2 ORDINANCE NO. 2022-1

6 AMENDING THE OFFICIAL ZONING MAP OF THE CITY OF SANTA FE AND
7 CHANGING THE CLASSIFICATION FROM R-5 (RESIDENTIAL – FIVE DWELLING
8 UNITS PER ACRE) TO R-7 (RESIDENTIAL – SEVEN DWELLING UNITS PER ACRE)
9 WITH RESPECT TO A CERTAIN PARCEL OF LAND COMPRISING
10 APPROXIMATELY 2.01 ACRES LOCATED AT 2190 WEST ALAMEDA STREET (CASE
11 NO. 2021-4244, 2190 WEST ALAMEDA STREET LOS CANALES REZONING).

Land Use Department Planning Commission Staff Report

EXHIBIT B1
 Technical Corrections
 Case #2021-4244 4245
 2190 W. Alameda Street Los Canales Final Development Plan

Water Mains

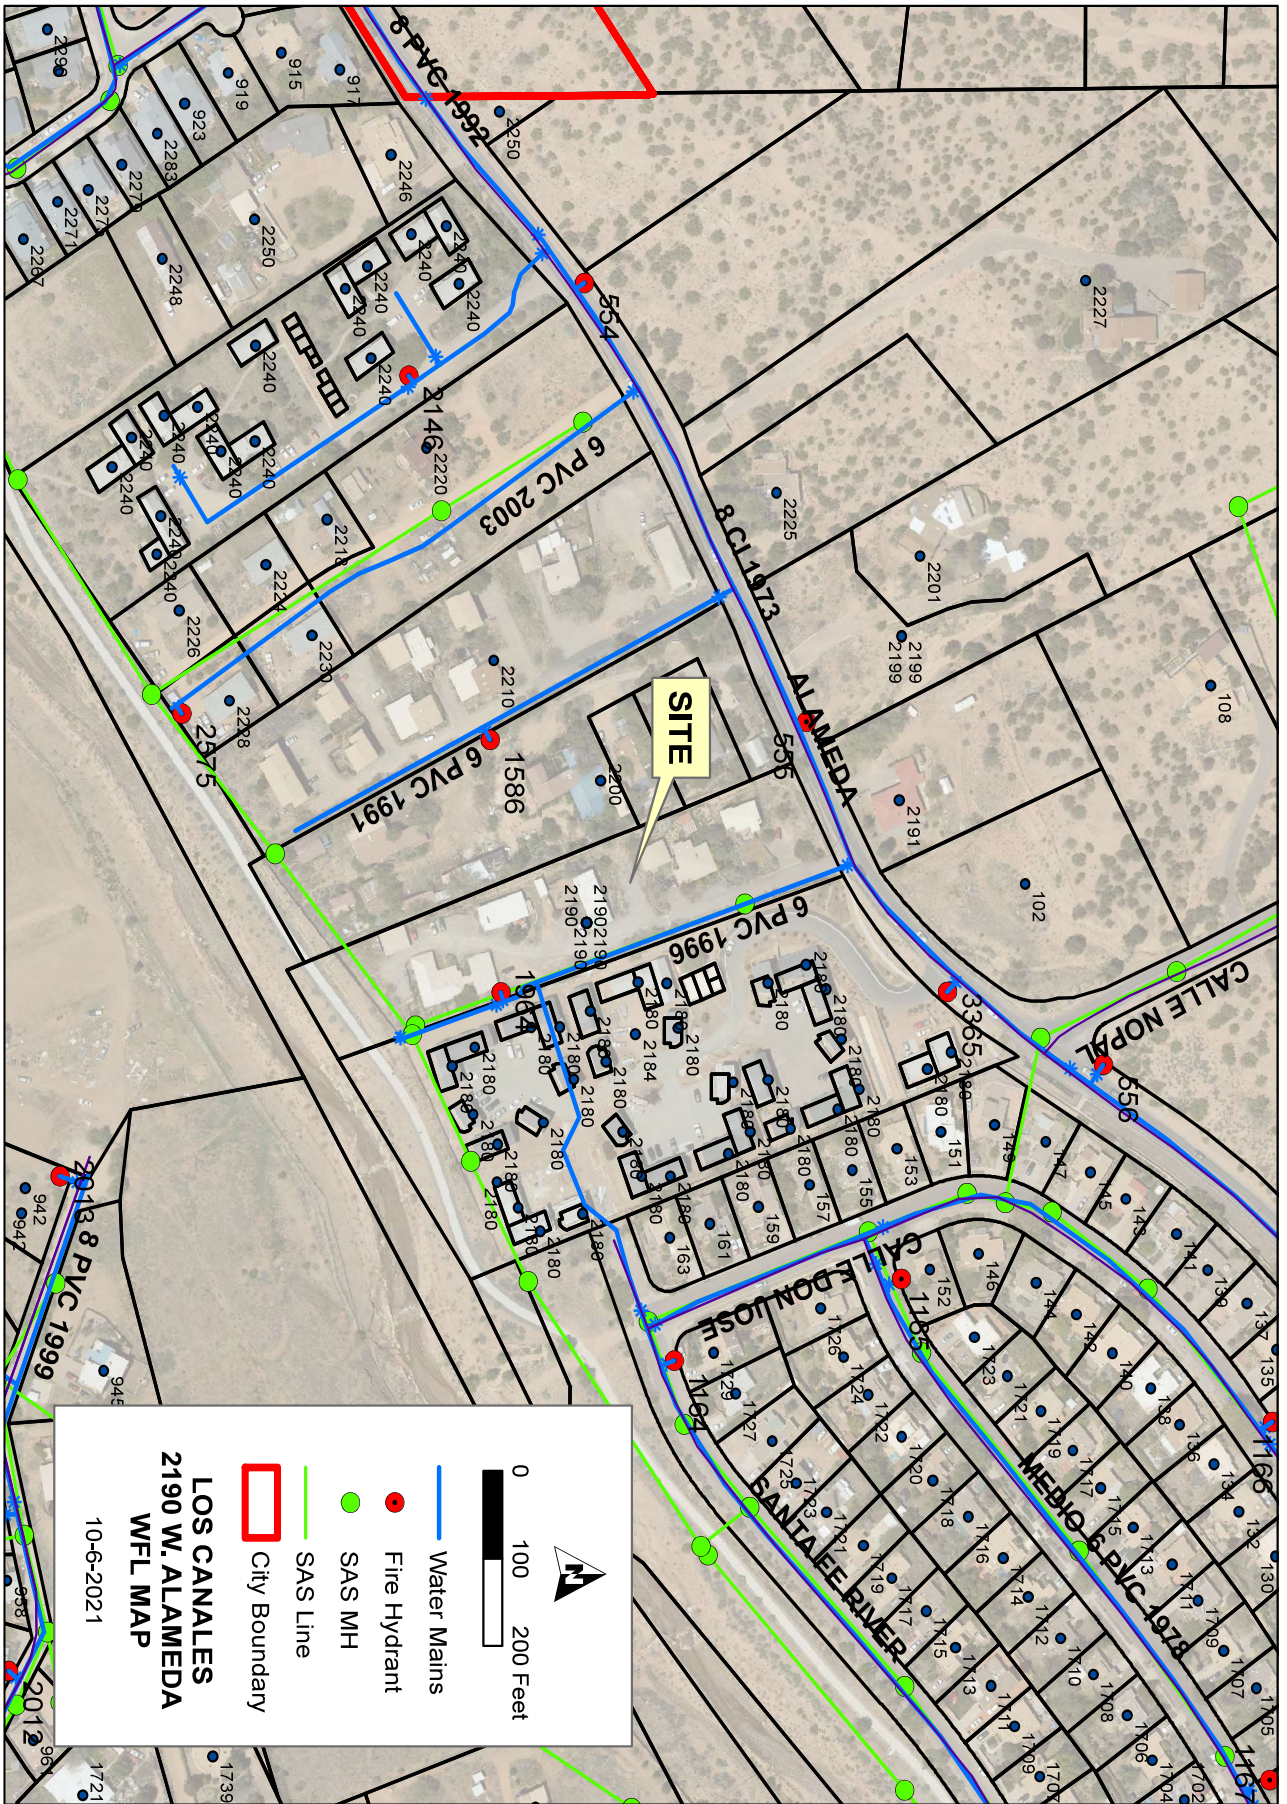
Water demand offset fees will be paid upon issuance of building permits for the five proposed dwellings. The Water Division is requiring the Applicant to extend the existing 6" water main west along the southern boundary of the property in order to allow for future looping for new development that may occur to the west. This looping will provide for increased water flow.

- Existing FH #1964 is currently rated at 750 gpm fire flow as it is an unlooped 6 inch main. Relocation of FH #1964 to a looped 6" main (move FH to the north about 50 feet and reconnect to existing 6" main) will increase fire flow rating to 1500 gpm.

ENERGY DISSIPATOR - PROFILE VIEW
SCALE: HORIZ. 1" = 2"
VERT. 1" = 2"

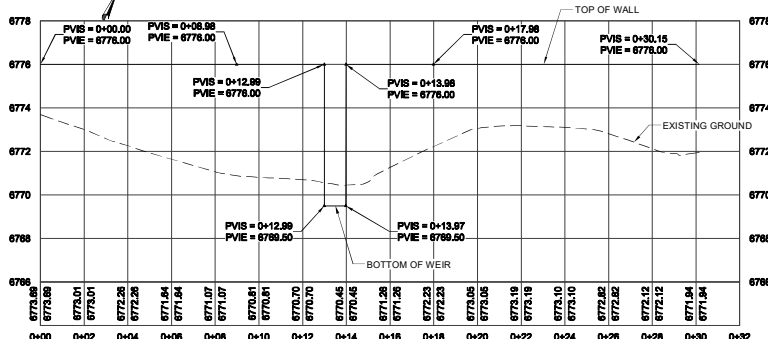
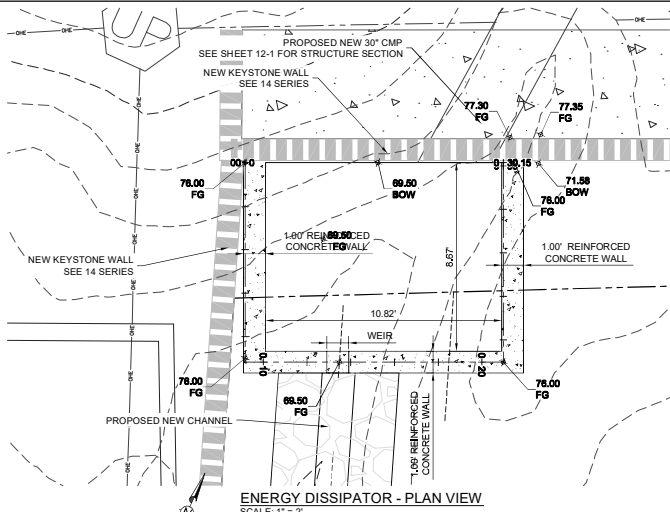
entering the deep water.		
5	Detail erosion protection at exit of energy dissipator.	Land Use/Terrain Management	Prior to Recordation
6	Include detail of check dam	Land Use/Terrain Management	Prior to Recordation
7	An approved Water Plan from the Water Division will be required. Water Plan comments will be submitted to the design engineer.	Public Utilities/Water	Prior to Recordation
8	Provide a 25' wide public sewer and waterline easement across southern portion of property. Utilize the existing sewer easement running parallel to the Santa Fe River and widen by 5 feet on south side of property.	Public Utilities/Water	Prior to Recordation
9	Extend the 6" water main along the southern boundary of the development to allow for looping for future developments to the west.	Public Utilities/Water	Prior to Recordation
10	Shall Meet all applicable ADA requirements (see comment form).	Land Use/ADA Site	Prior to Recordation
